Office Action Summary

09/781,327

HAKOGI ET AL.

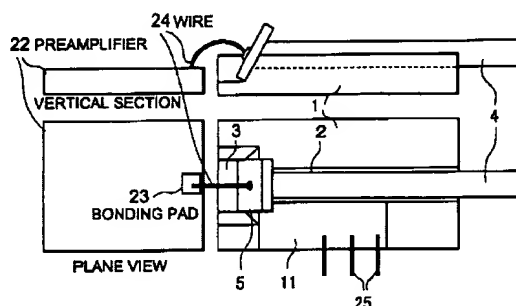
Tachigori discloses an optical module comprising: an optical fiber ('4', Fig. 10-reproduced above) having a slope end surface; a photodetector ('5') mounted on the slope end surface, and optically coupled directly with the optical fiber, the slope end surface being inclined with respect to an optical axis in the fiber (Fig. 10 above); wherein the end surface of the photodetector is inclined with respect to the optical axis in the fiber (Fig. 10 above); and the photodetector having electrodes on a rear surface thereof opposite to a front surface thereof attached to the slope end surface ('24' Fig. 10 above).

However, Tachigori does not explicitly teach the use of a ferrule, such that the optical fiber end is held in a ferrule. Nevertheless, the use of a fiber ferrule on optical fiber ends is well known and common in the art. The use of a fiber ferrule is well known to be advantageous and desirable because ferrules provide mechanical support for fragile fiber ends, such that physical coupling between the fiber ends and optical devices (such as a photodetector) does not cause

In addition, Tachigori discloses: a module substrate supporting the fiber ('1' Fig. 10); electronic parts mounted on the module substrate ('11', '25'); the photodetector being adhered to the slope end surface (Fig. 10 above).

However, Tachigori does not explicitly teach: that the photodetector has a size smaller than the area of the slope end surface (as claimed in claims 1 and 6 of the instant application); a resin package covering a portion of the fiber (as claimed in claim 1); a supporting base mounted on the module substrate (as claimed in claim 2); wherein the resin package has engagement protrusion which are to be engaged with an optical connector, and the engagement protrusion extend along side surfaces of the resin package (as claimed in claims 4 and 5).
